TOWN OF NISKAYUNA
Planning Board and Zoning Commission
Agenda
November 28, 2022 7:00 PM

TOWN OF NISKAYUNA
Planning and Zoning Commission
Hybrid Meeting
Meeting Minutes
November 14, 2022

RE: *Joralemon 2-Lot Minor Subdivision*
Sketch Plan Submission
C.T. Male Project No: 04.9065

LAYOUT PLAN
2 - LOT MINOR SUBDIVISON

C-101

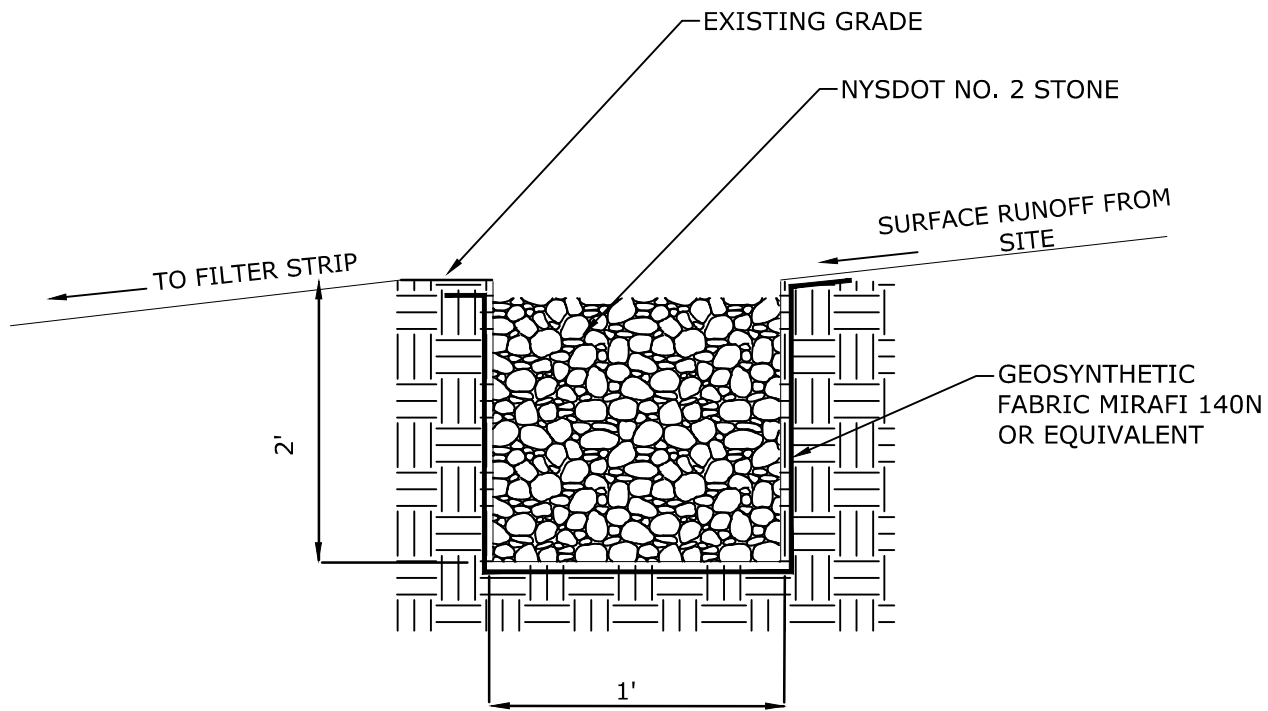
- As the 120' filter strip is a critical component of the post-construction stormwater design to provide runoff reduction by conservation of natural areas, it is our opinion that a permanent easement or deed restriction should be considered so that this area is not allowed to be altered in the future.

11. The applicant has stated that the 120' filter strip is to remain as green/undisturbed area as shown on the plans, and no permanent easement or deed restriction has been offered so that this area is not allowed to be altered in the future. **The Planning Board will need to decide if this is acceptable.**

An updated version of the site plan drawings dated 11/16/22 were received by the Planning Office on 11/22/22. Notes were added regarding the deed restriction of the land and the inspection and maintenance requirements of the filter strip.

Response: A note has been added to the plan stating, "gravel diaphragm level spreader to be inspected and maintained per the requirements of the project SWPPP with included O&M manual."

Response: The applicant has agreed to deed restrict this area. A note has been added to the plan stating, "filter strip to be deed restricted to not allow development or altering of the filter strip area shown hereon."

C-501
SHEET 2 OF 2
DWG. NO: 04.9065

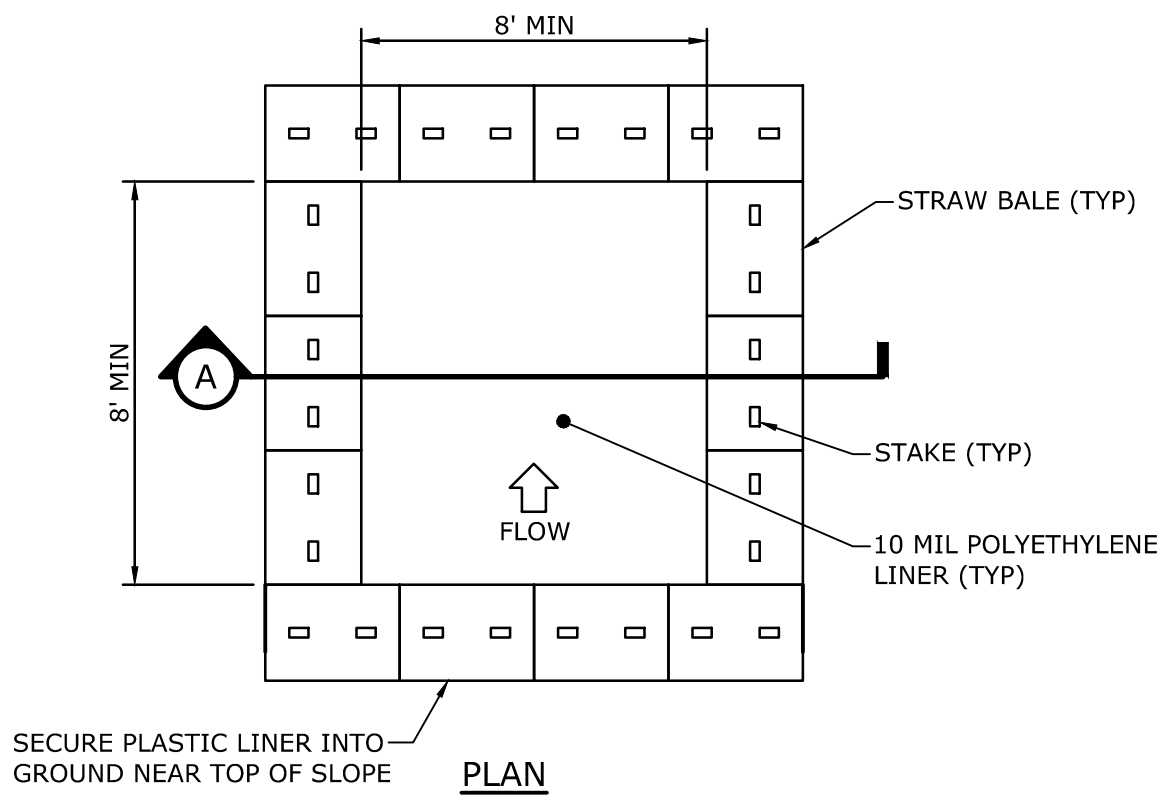
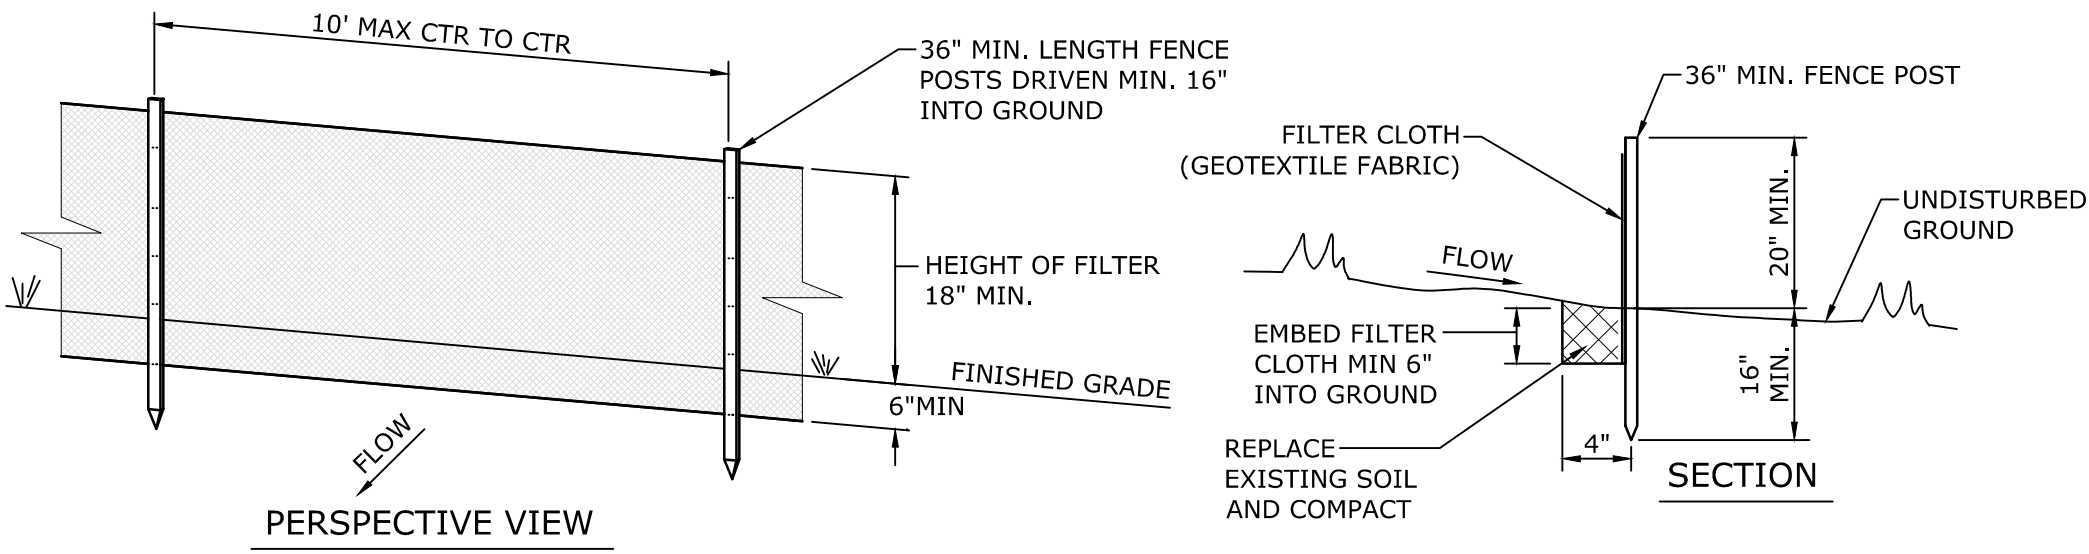
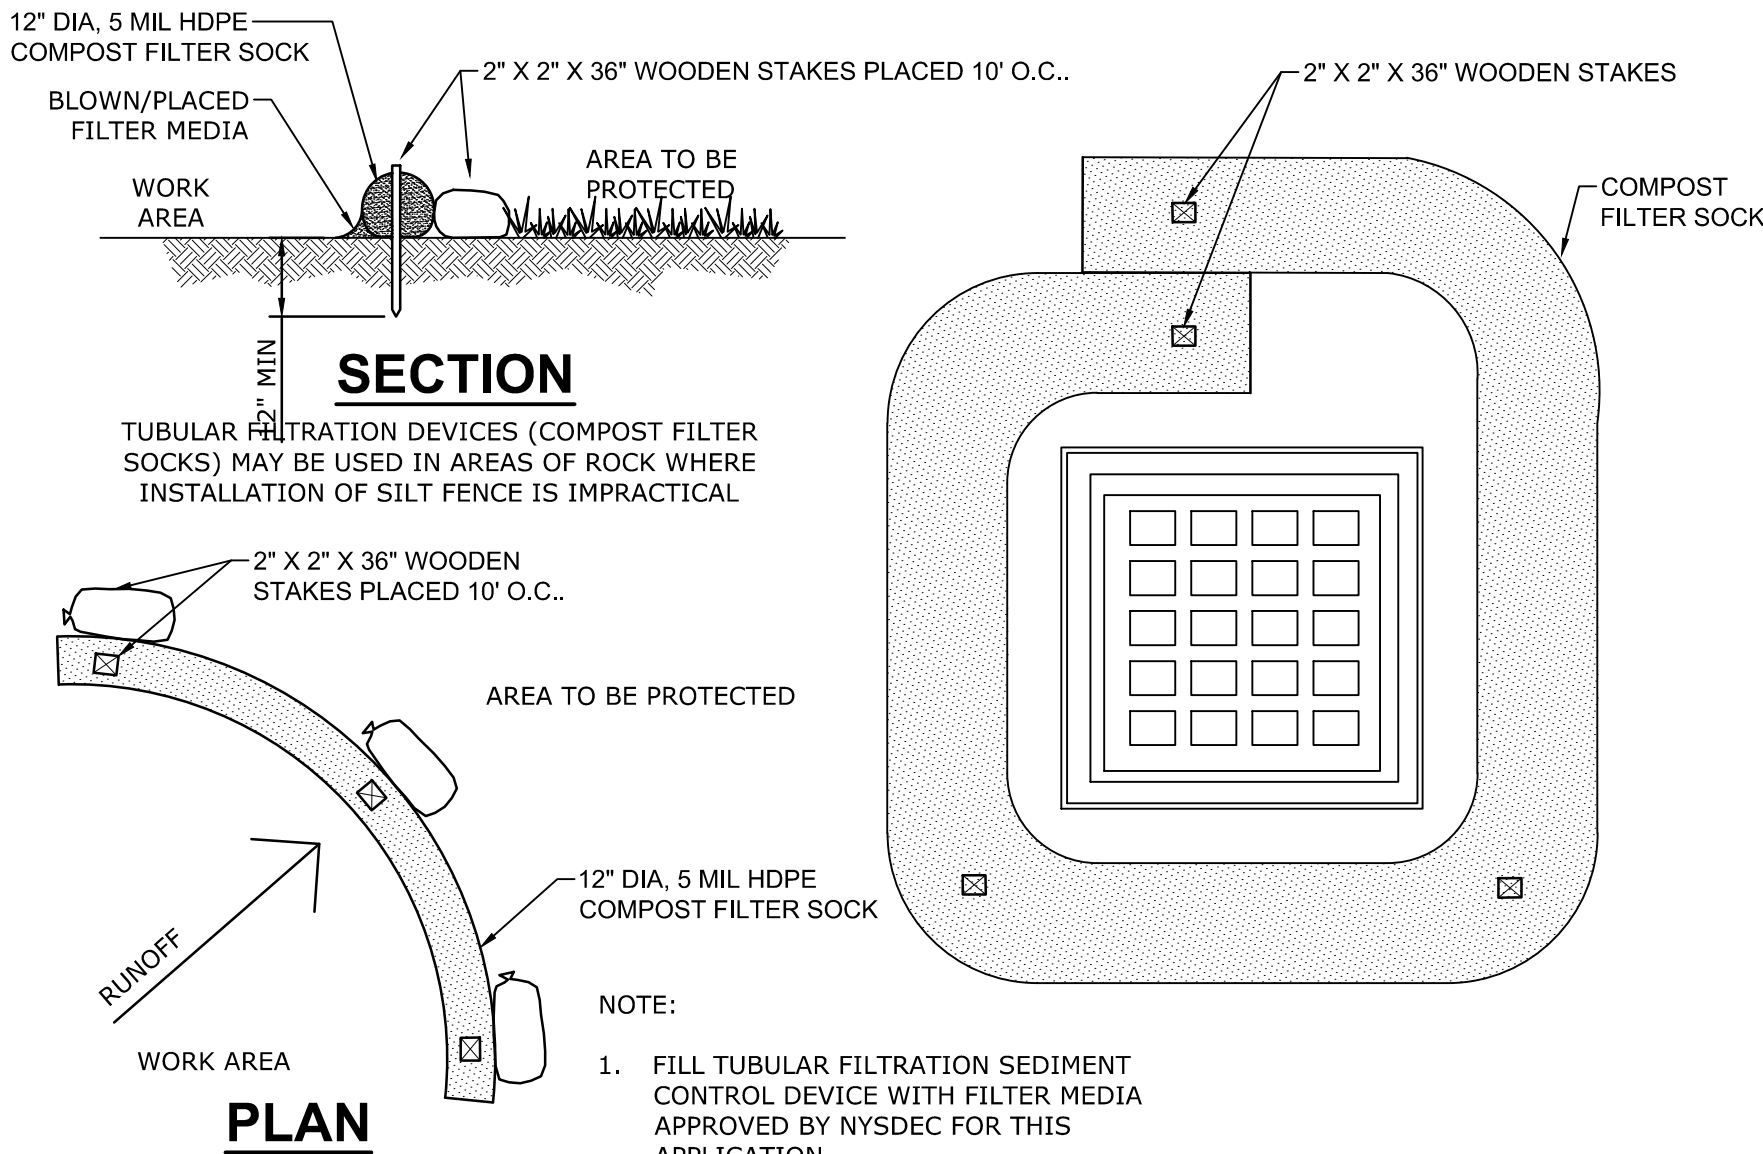
7. A detail of the level spreader has been added to the drawing set.
8. The site plan has been revised to show the 25 feet of level grass for the boundary zone ahead of the filter strip.

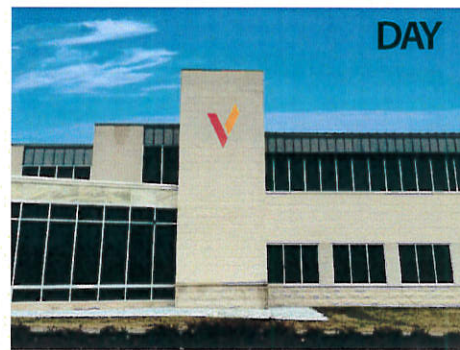
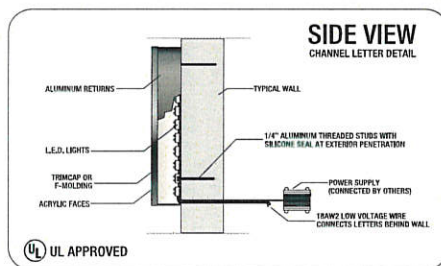
As proposed, the building frontage exceeds 50’ in length and the signs shown on the drawing entitled “Momentive CH LTTRS opt4” constitute two façade signs. The “Momentive” sign measures 297” wide x 48” high (99 sq. ft.). **Therefore, a variance of 49 sq. ft. of façade sign area is required.**

As proposed, the “V” sign is the second façade sign on the property and measures 52” wide x 72” high (26 sq. ft.). **Therefore, a variance for a second façade sign measuring 26 sq. ft. is required.** The Planning Office notes that some vague documentation exists in Town records indicating that at one time two façade signs existed on the property.

RECOMMENDATION – The Planning Board voted 7 – 0 in favor of recommending the Zoning Board of Appeals (ZBA) grant the two variances.
